# RETREAT AT TIMBERRIDGE FILING NO. 4

## CONSTRUCTION DRAWINGS

EPC STORMWATER REVIEW COMMENTS  
IN ORANGE BOXES WITH BLACK TEXT

ENGINEERING REVIEW COMMENTS IN  
BLUE BOXES WITH BLUE TEXT

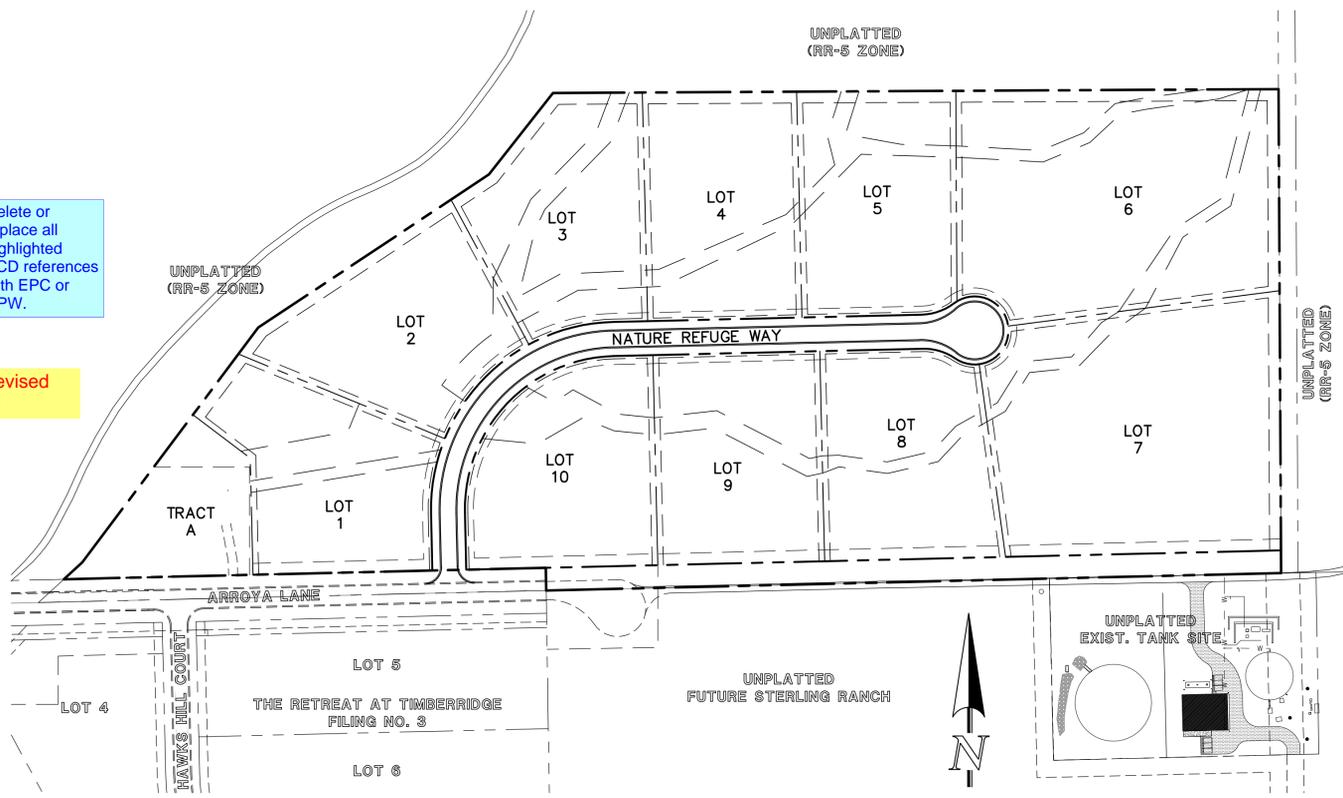
Delete or  
replace all  
highlighted  
PCD references  
with EPC or  
DPW.

Ok. But we only  
included separate  
GEC plan in EDARF  
submission because  
Planner provides  
spot for GEC Plan.

Revised  
all

Since the GEC Plan is  
within the CDs, no need to  
submit the GECs separate  
for future submittals

<p>RETREAT AT TIMBERIDGE FILING NO. 4 CONSTRUCTION DRAWINGS GRADING AND EROSION CONTROL PLAN</p>			
DESIGNED BY	PRA	SCALE	DATE 1-15-24
DRAWN BY	PRA	(H) 1" = 50'	SHEET 3 OF 14
CHECKED BY	(V) 1" = N/A	JOB NO.	1185.31

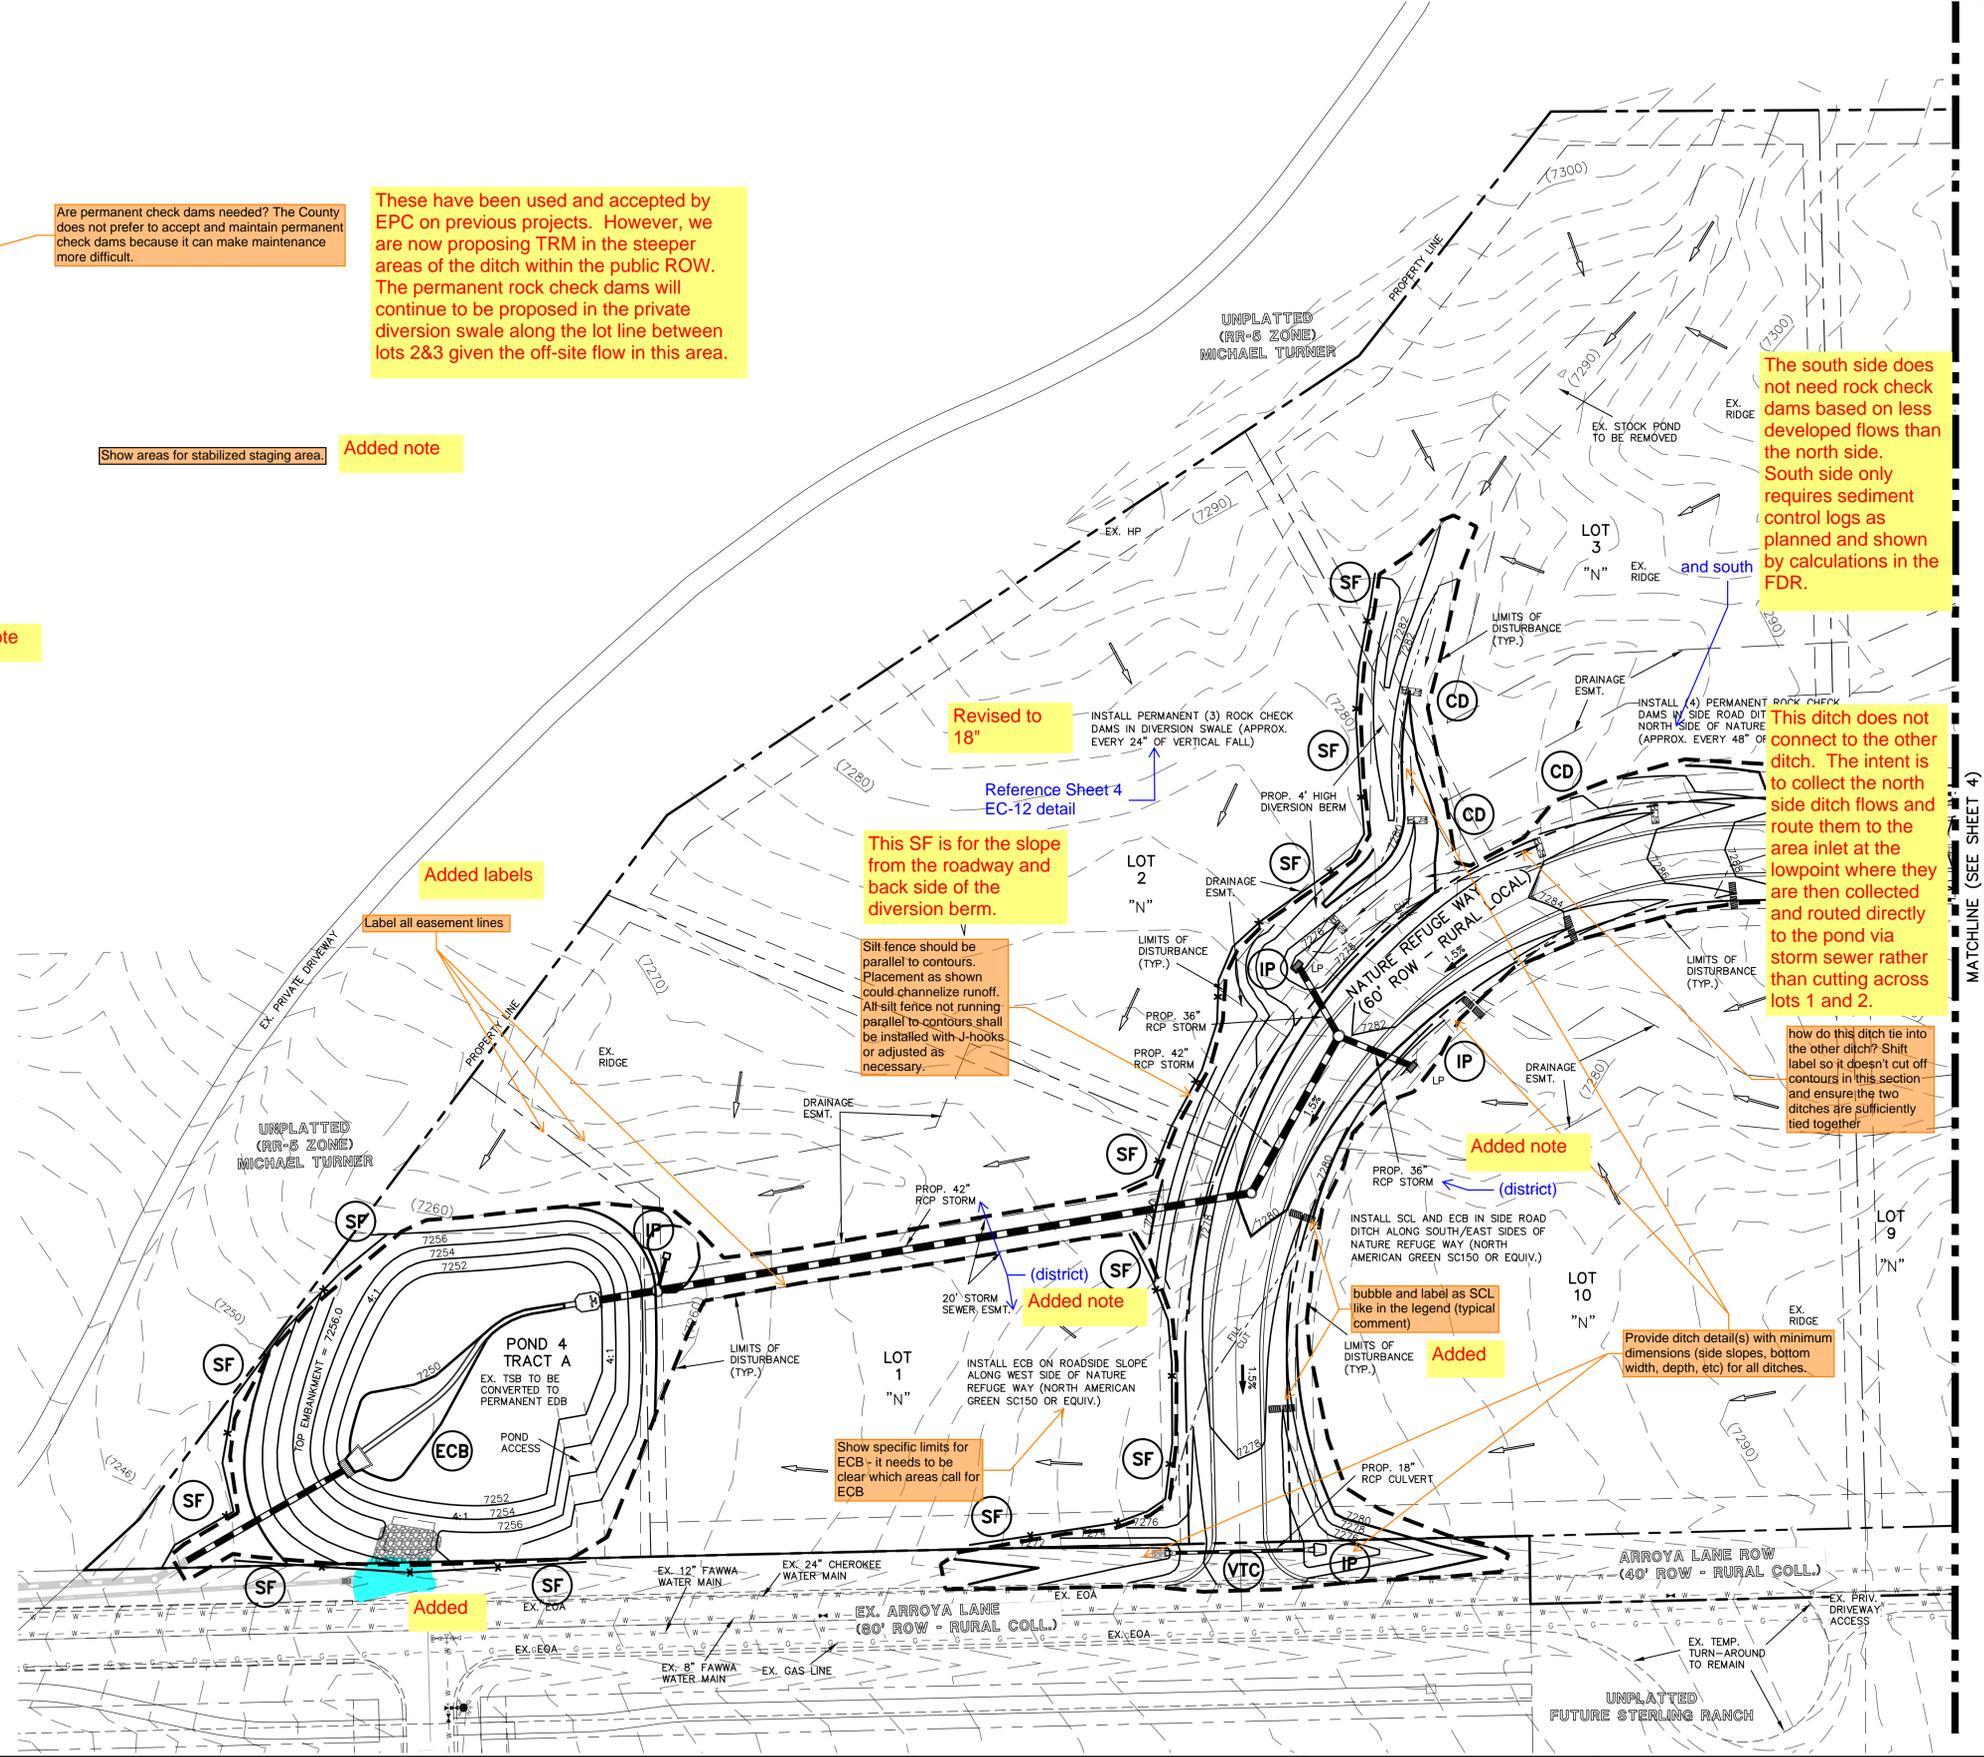
Are permanent check dams needed? The County does not prefer to accept and maintain permanent check dams because it can make maintenance more difficult.

Show areas for stabilized staging area. Added note

Show areas for stockpiling and staging, clarify if they aren't anticipated, or add a note that those will be determined by the contractor. Added note

All are listed as through the vertical phase, but clarify which are to be final to be left and which are to be removed with final stabilization. Seeding and mulching are final and not on the phasing list.

These have been used and accepted by EPC on previous projects. However, we are now proposing TRM in the steeper areas of the ditch within the public ROW. The permanent rock check dams will continue to be proposed in the private diversion swale along the lot line between lots 2&3 given the off-site flow in this area.

Revised Notes

RETREAT AT TIMBERIDGE FILING NO. 4  
CONSTRUCTION PLANS  
STREET LIGHT POLE LOCATION PLAN

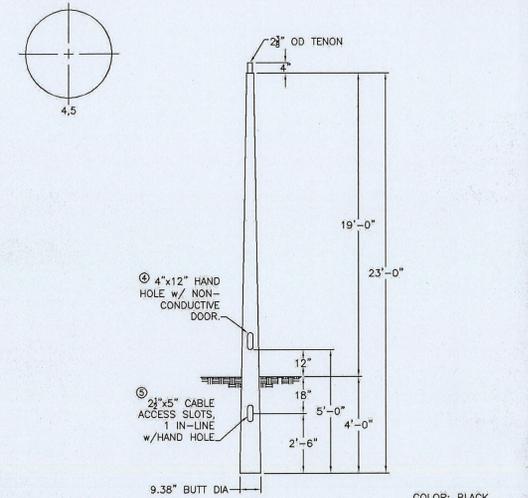
Provide a typical section on where light poles will be placed outside of clear zone and ditch

Clear description of pole locations already contained in note above. However, now added pole locations and note to roadway section and included on this sheet.
